**MILLSTONE NUCLEAR POWER STATION  
HEALTH PHYSICS SUPPORT PROCEDURE**

**Inspection and Maintenance Process for  
Respiratory Protection Equipment**

**RPM 2.3.4**

**Rev. 002-01**

**Flowchart Number 1 – MSA Full Facepiece or Half Mask Respirator**

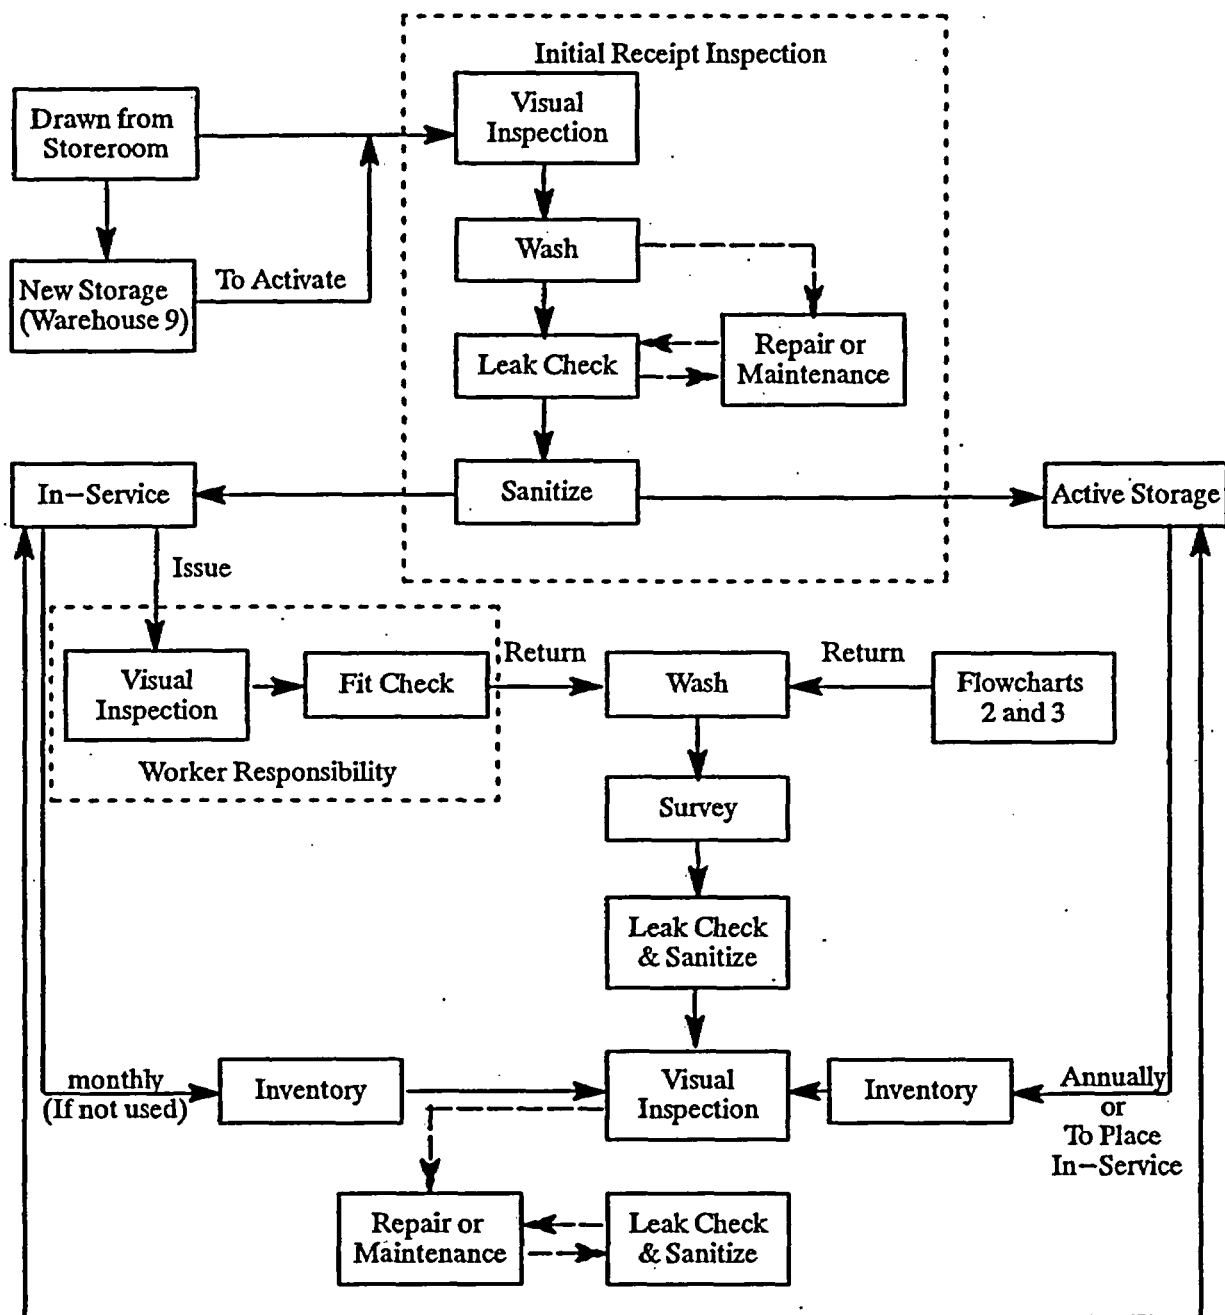
- 4.4 Changes in Attachment 1:
  - 4.4.1 Changed Flowchart Number 1 In-Service Inventory from quarterly to monthly and reformatted steps to comply with 29CFR1910.
  - 4.4.2 Deleted time frame for Hydrostatic Test from Flowchart Number 3. This test is dependent on cylinder type and is discussed in RPM 2.3.5.

- 4.4.3 Deleted "(Posichck)" from "Functional Check (Posichck)" in Flowcharts Number 1, 3 and 4.
- 4.4.4 Changed titles of cylinders in Flowchart Number 4 to distinguish composite cylinders and fiberglass wrapped cylinders as these two types of cylinders have different inspection criteria.
